Technical product information

| Topic | Water ingress onto the front reading light |

Bentayga Series

Figure 4

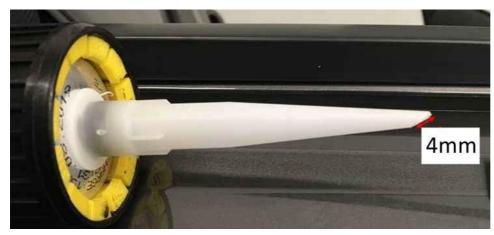
3) Then take the 1k window adhesive D 169.300.M1 and cut off the front cartridge nozzle diagonally, so that an opening of around 4mm is created (Figure 4)
